LICENSEE: INDIANA MICHIGAN POWER COMPANY
FACILITY: DONALD C. COOK NUCLEAR PLANT, UNITS 1 AND 2
SUBJECT: SUMMARY OF AUGUST 12, 2009, CATEGORY 1 PUBLIC MEETING VIA
CONFERENCE CALL TO DISCUSS RESPONSES TO GENERIC LETTER
2004-02 REQUESTS FOR ADDITIONAL INFORMATION (TAC NOS. MC4679
AND MC4680)

DRAFT
Response to June 18, 2009 Request for Additional Information (RAI)
To Support August 12, 2009 Teleconference Between
Nuclear Regulatory Commission (NRC) And D. C. Cook Nuclear Plant (CNP)

Figure 4-4

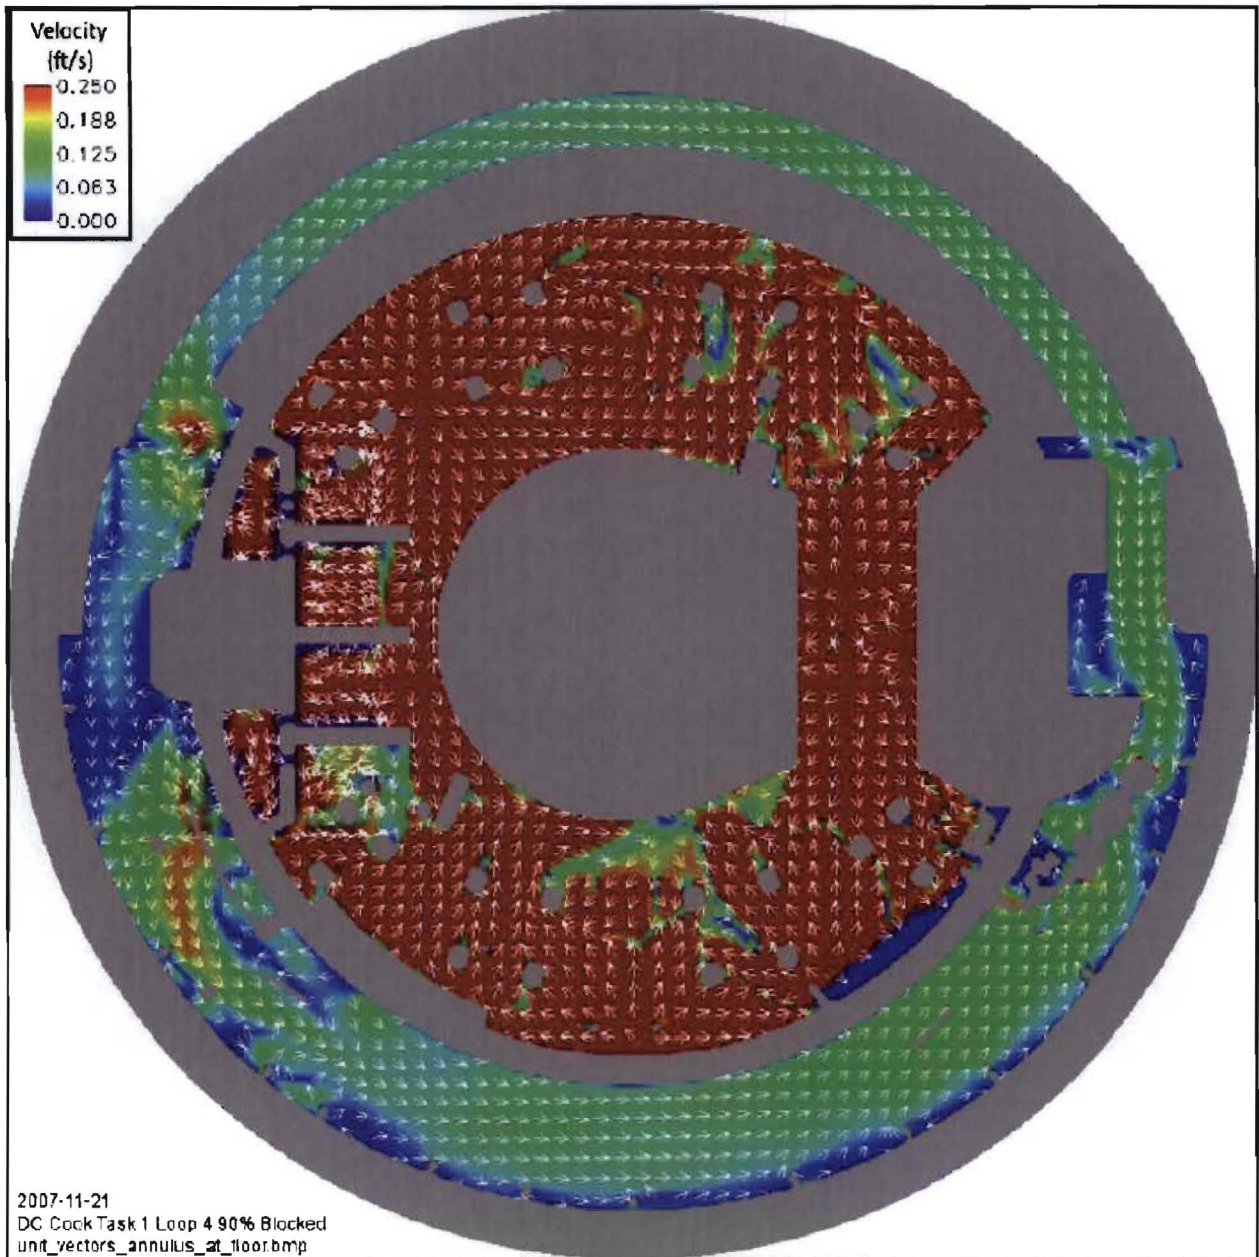
c) The basis for using a velocity of 0.4 ft/s, since calcium silicate pieces larger than those tested (i.e., in the large piece category) would not transport at this velocity based on the metric of 0.52 ft/s cited in Table 3e1-5 in the February 29, 2008 supplemental response. As a result of exposure to higher velocity flows than tested, erosion from settled large pieces of calcium silicate could be underestimated.

To address this question, pool floor specific velocities are being developed to validate that the expected velocity will be below the tested velocity. Figure 4-4, Attachment 4, provides some indication of the sump pool velocities that exist at the floor during recirculation. This information shows that the expected velocities are below 0.4 ft/sec. The information cited from the February 29, 2008 supplemental response refers to the velocity required to transport large pieces of Cal-Sil. The only time period during which sump pool velocities exceeded 0.4 ft/sec is during the pool fill period which was assumed to occur for approximately 18 minutes. Figure 4-3, Attachment 4, illustrates the turbulent kinetic energy and velocity in the pool at the end of pool fill. As stated at the beginning of this response, additional velocity diagrams are being developed to demonstrate that the pool floor velocities remain below 0.4 ft/sec, except for the short duration during pool fill. Additional information regarding the basis for use of 0.4 ft/sec for erosion testing is provided in the following excerpt from the ALION test report, ALION-REP-AEP-4462-02, D. C. Cook Material Transport, Erosion and Dissolution Report:
